DEPARTMENT OF COMMUNITY DEVELOPMENT SERVICES

DATE: June 3, 2016

SUBJECT: Plan Case 2276-PUD-16 & Plan Case 2277-PUD-1: A request on behalf of Vision Housing LLC for preliminary and final approval of a residential Planned Unit Development at 802, 804, and 806 South Lincoln Avenue and 809 West Nevada Street under Section XIII-3 of the Urbana Zoning Ordinance.

4 5TH FLOOR PLAN
 SCALE: NOT TO SCALE

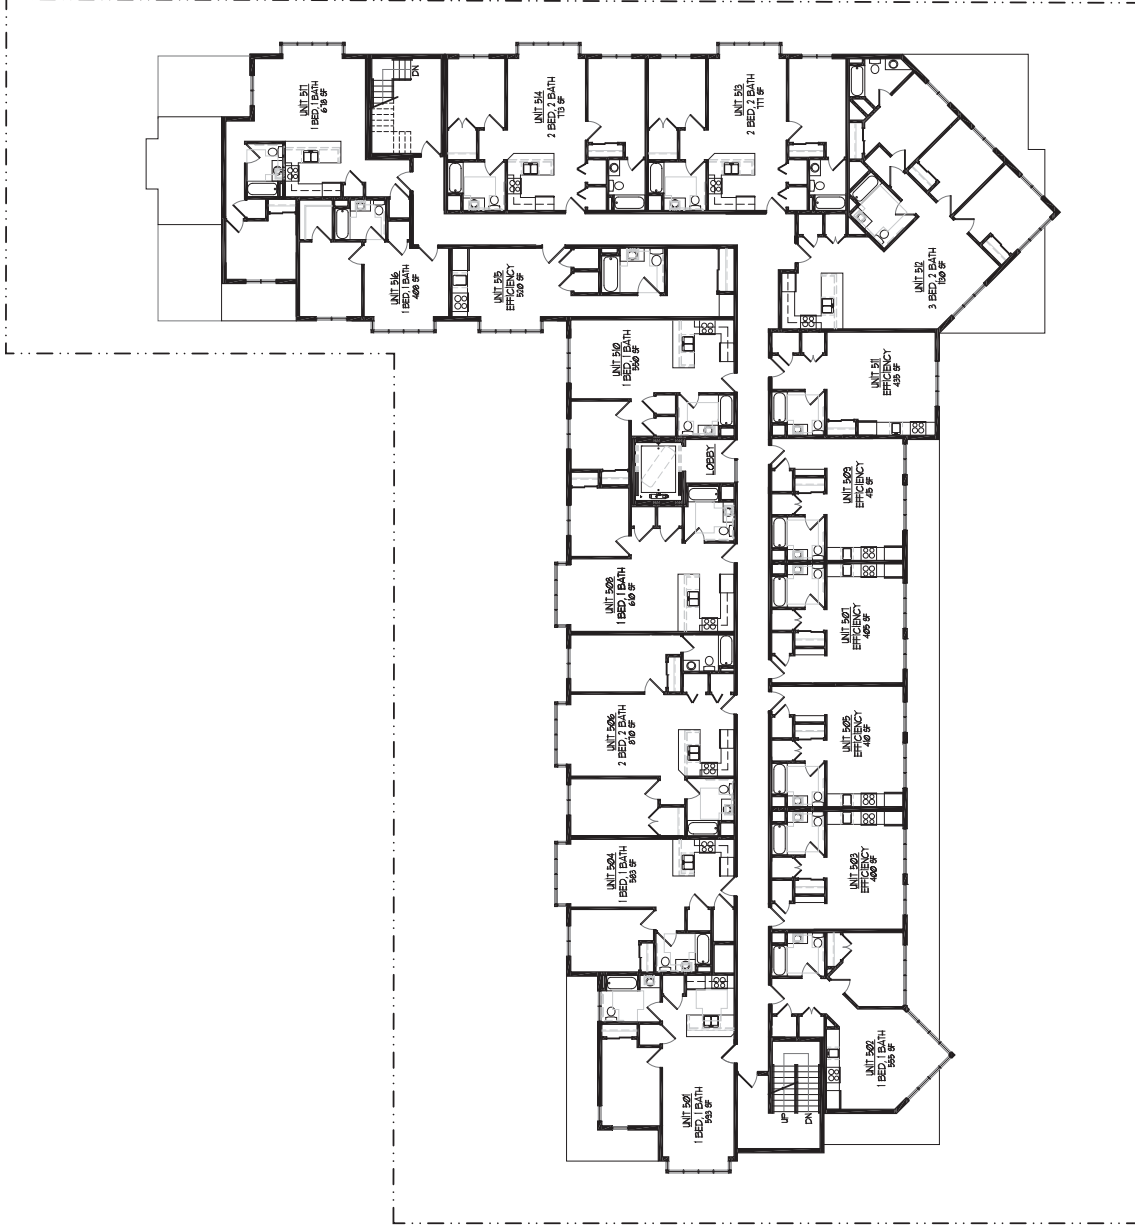
The applicant proposes a revision to reduce the number of units on the fifth floor along the east side of the building. The fifth floor is therefore is designed to be set back from the edge and finished with a lighter-color panel to reduce the perception of height. The building as a whole is proposed with large banks of windows to help interrupt the building's mass and provide visual interest. It is recommended that further revisions to the design be considered to reduce the building's apparent bulk and height and to further break up the building's mass.

2. That the design be reviewed and approved by the Design Review Board as specified by Section XI-15 of the Zoning Ordinance.
3. That the building design be revised to: a) consider eliminating the fifth floor and b) further break up the building's massing through articulation, use of a courtyard feature along Lincoln Avenue, or other means.
